Project Name: Banyan Court

Request: Master Development Plan Approval

PLANNING AND ZONING BOARD STAFF REPORT

Banyan Court (fka Banyan Cove) Rezoning

Photometric Plan

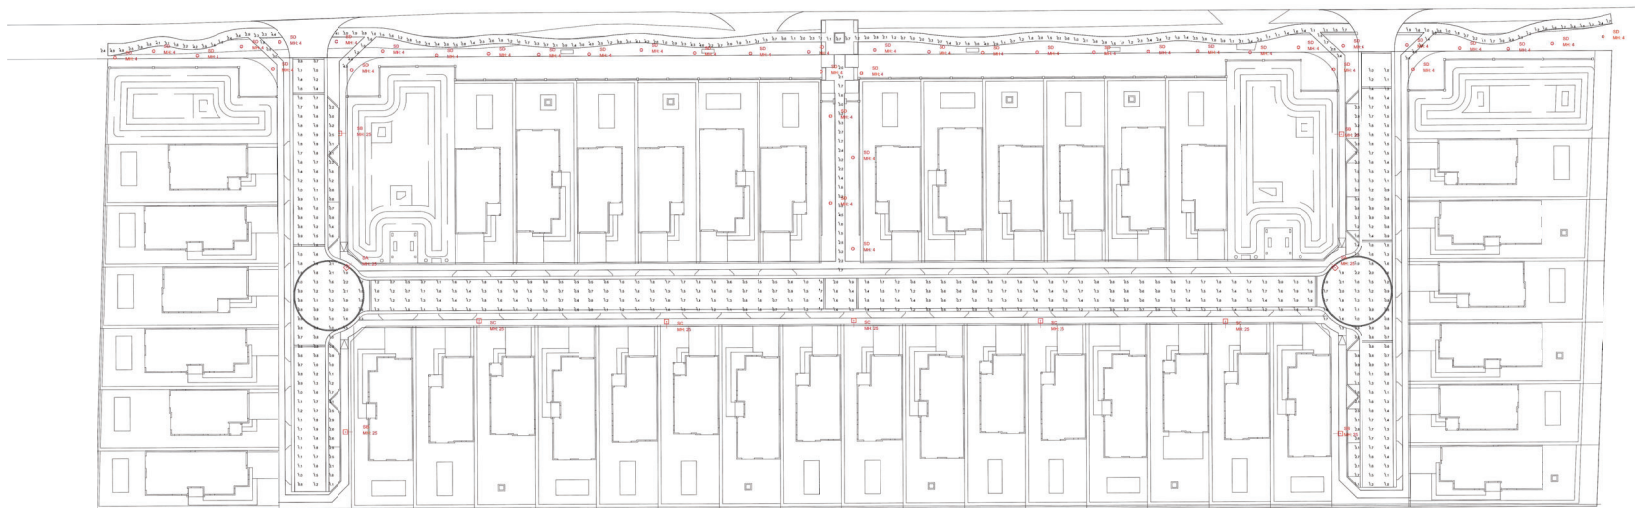
- The photometric plans show items labelled SD MH: 4 and SD MH: 1 out in the Right-of-Way of Barwick Road but these items are not identified as to what they are. There are details for a bollard light and a pole mounted light neither of which are acceptable to be placed in Barwick Road Right-of-Way although they are perfectly acceptable within the private roads/common areas. The City will require use of the City Standard light pole in Barwick Road Right-of-Way. This must be accomplished prior to Site Plan Certification.
